SECTION 4.55 (1A) SUBMISSION

PROPOSED ALTERATIONS AND ADDITIONS TO
 22 ABERNETHY STREET
 SEAFORTH NSW
 LOT 1 DP 91180

ELEVATIONS

ROOF PLAN

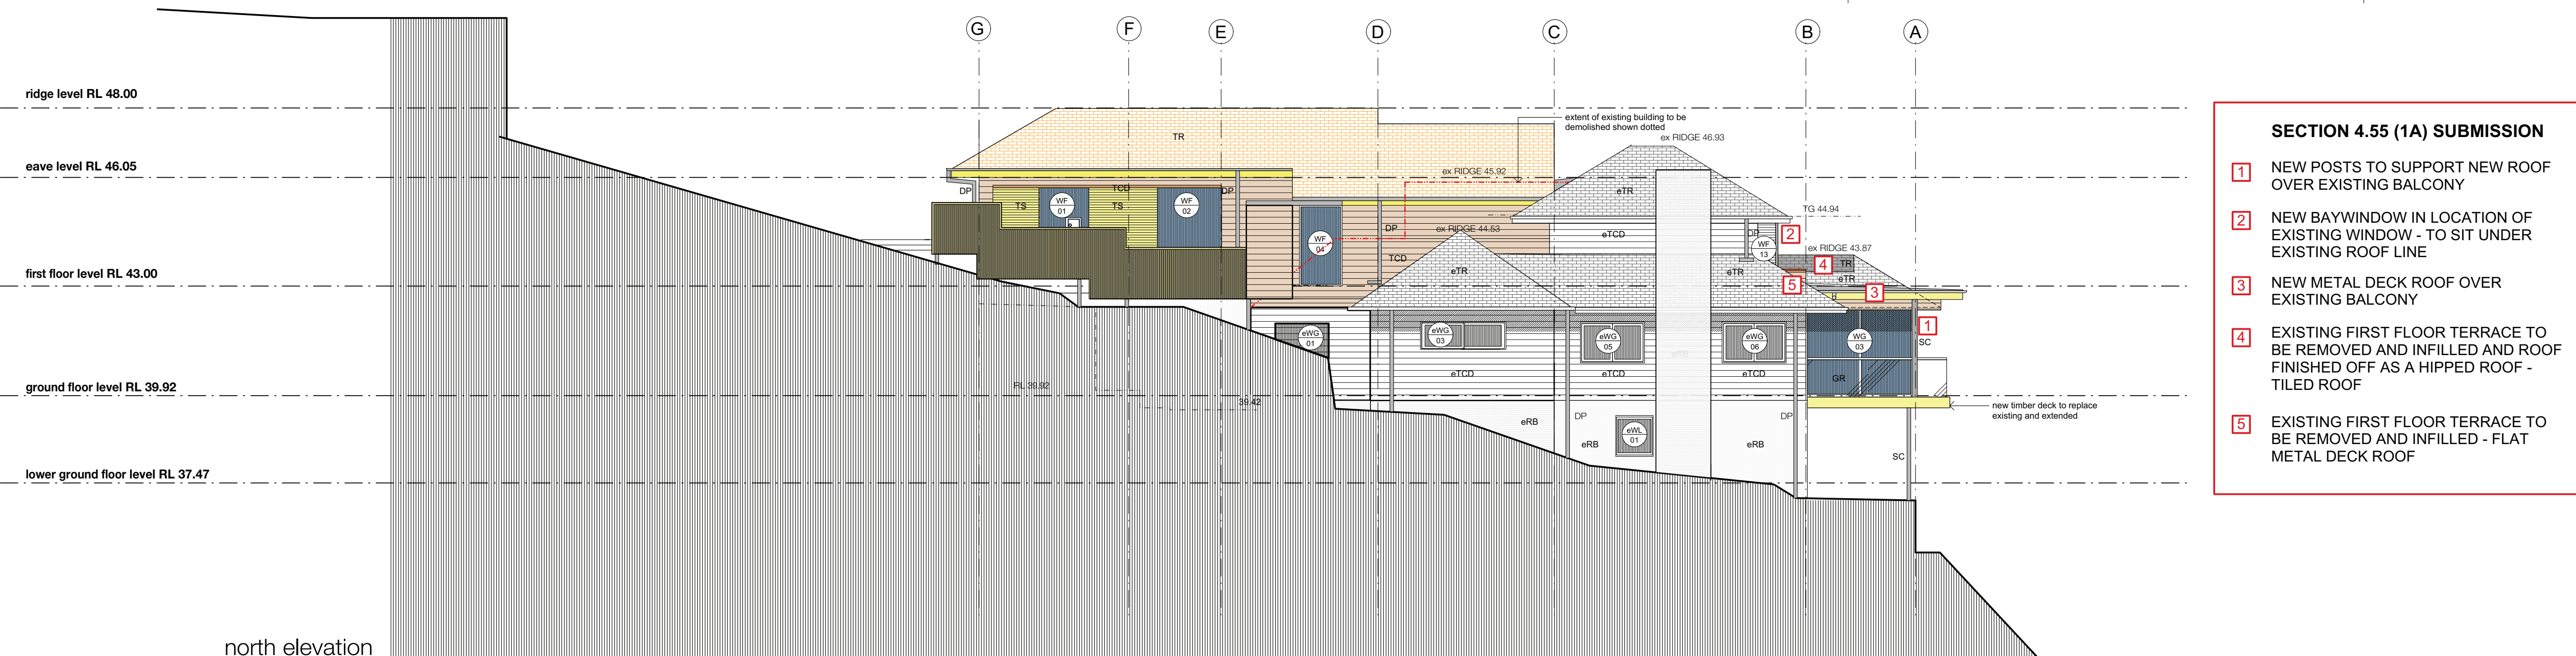
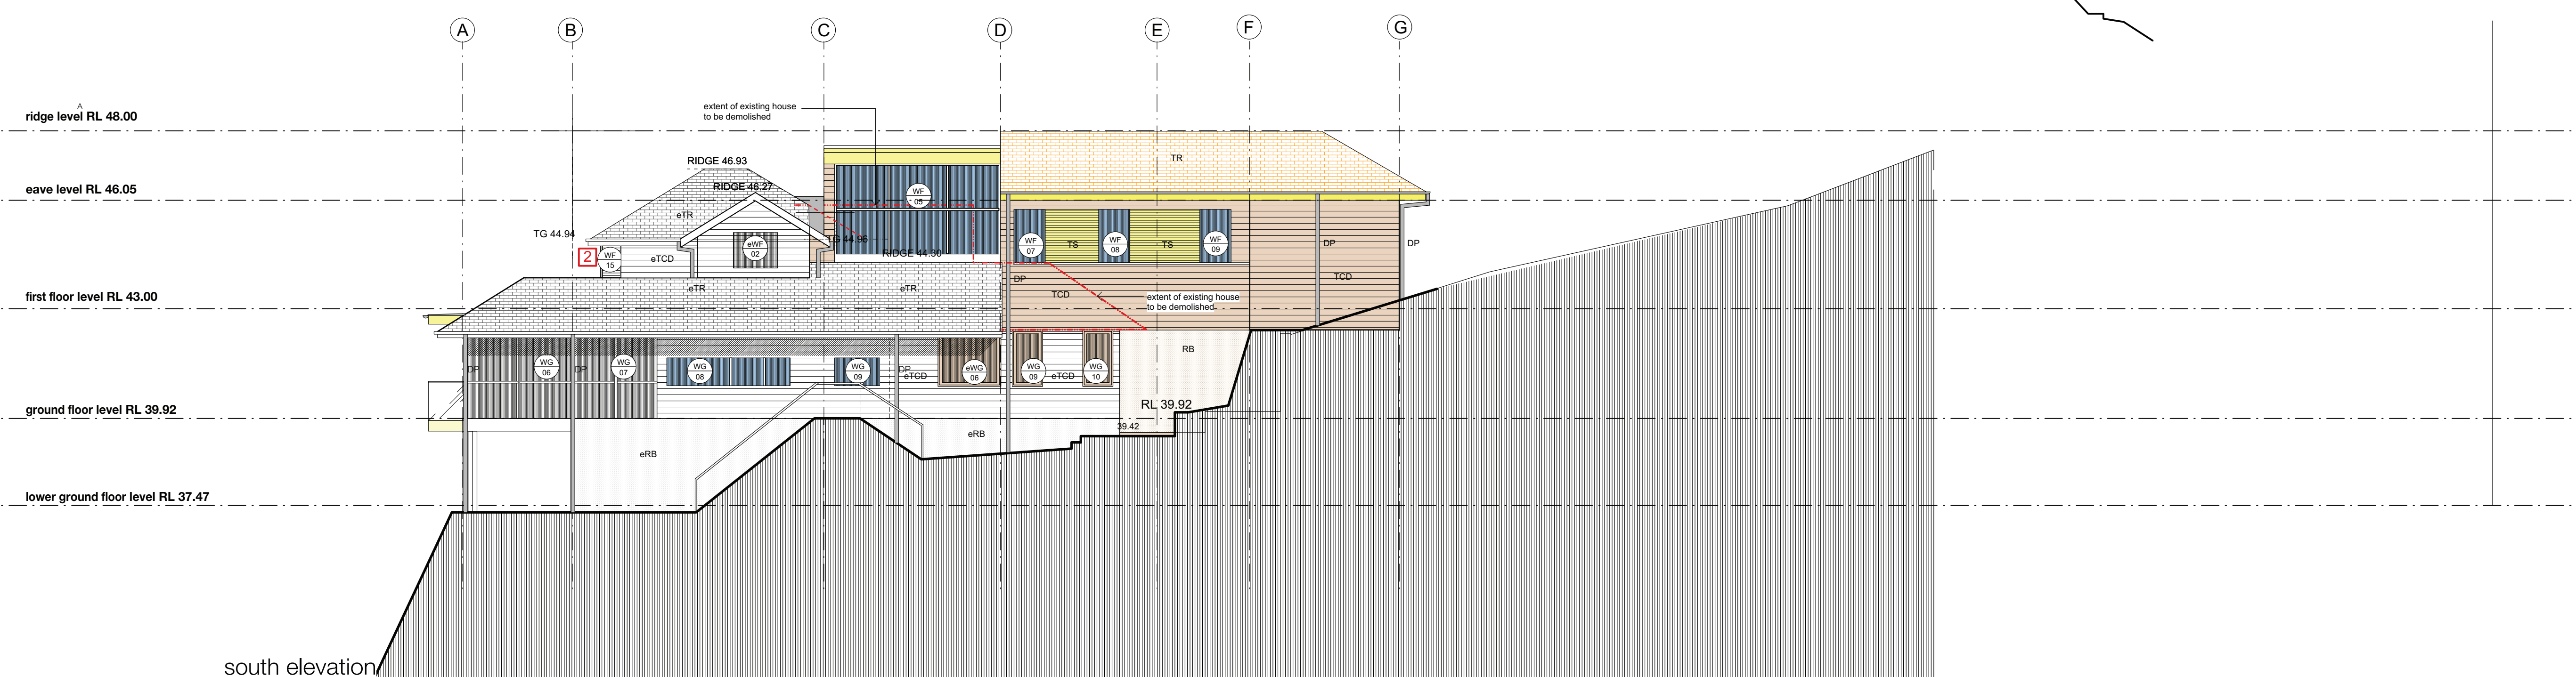
- 1 NEW POSTS TO SUPPORT NEW ROOF OVER EXISTING BALCONY
- 2 NEW BAYWINDOW IN LOCATION OF EXISTING WINDOW - TO SIT UNDER EXISTING ROOF LINE
- 3 NEW METAL DECK ROOF OVER EXISTING BALCONY
- 4 EXISTING FIRST FLOOR TERRACE TO BE REMOVED AND INFILLED AND ROOF FINISHED OFF AS A HIPPED ROOF - TILED ROOF
- 5 EXISTING FIRST FLOOR TERRACE TO BE REMOVED AND INFILLED - FLAT METAL DECK ROOF

Issue	Date	Amendment
D	11.07.16	S.4.55 ISSUE: ROOF ADDED TO TERRACE, BAY WINDOW ADDED TO BED 1, FIRST FLOOR ROOF TERRACES DELETED
B	04.04.17	KITCHEN LAYOUT MODIFIED
C	28.07.17	TENDER ISSUE
B	23.08.16	DEVELOPMENT APPLICATION ISSUE
A	23.03.16	DESIGN REVIEW

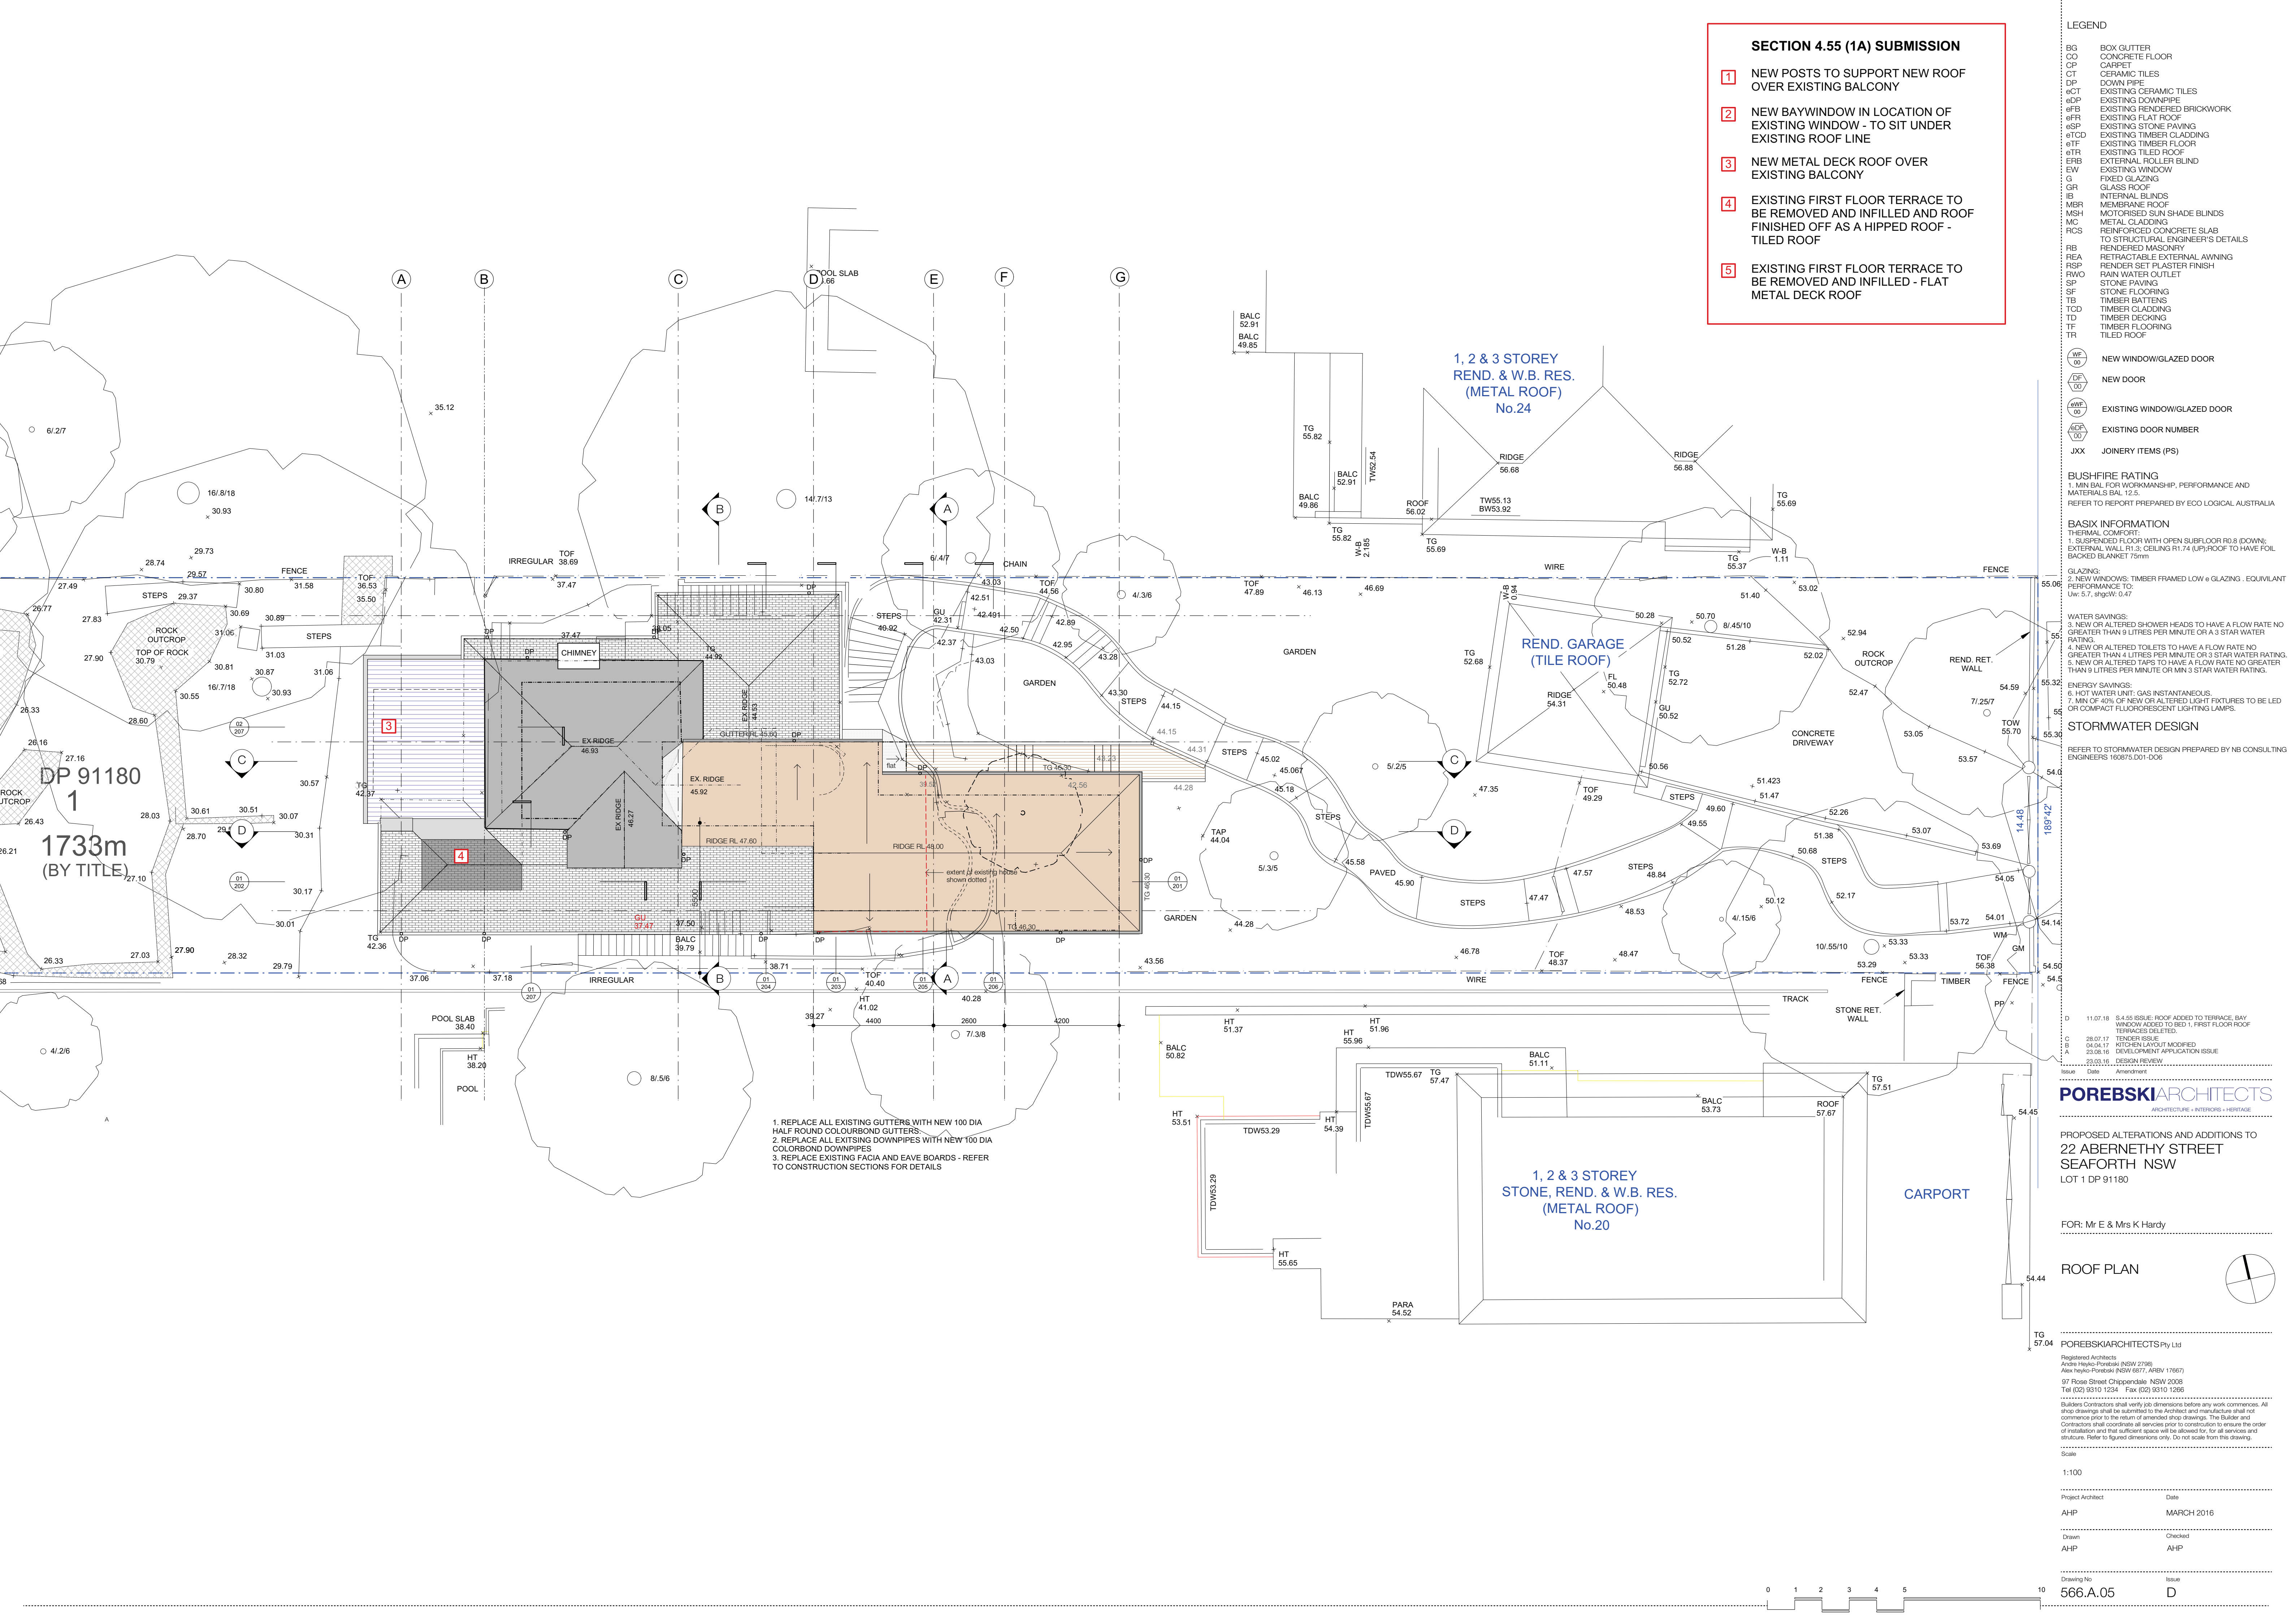
- SECTION 4.55 (1A) SUBMISSION**
- 1 NEW POSTS TO SUPPORT NEW ROOF OVER EXISTING BALCONY
 - 2 NEW BAYWINDOW IN LOCATION OF EXISTING WINDOW - TO SIT UNDER EXISTING ROOF LINE
 - 3 NEW METAL DECK ROOF OVER EXISTING BALCONY
 - 4 EXISTING FIRST FLOOR TERRACE TO BE REMOVED AND INFILLED AND ROOF FINISHED OFF AS A HIPPED ROOF - TILED ROOF
 - 5 EXISTING FIRST FLOOR TERRACE TO BE REMOVED AND INFILLED - FLAT METAL DECK ROOF

Date	Amendment
11.07.16	S.4.55 ISSUE: ROOF ADDED TO TERRACE, BAY WINDOW ADDED TO BED 1, FIRST FLOOR ROOF TERRACES DELETED
28.07.17	TENDER ISSUE
04.04.17	KITCHEN LAYOUT MODIFIED
23.08.16	DEVELOPMENT APPLICATION ISSUE
23.03.16	DESIGN REVIEW
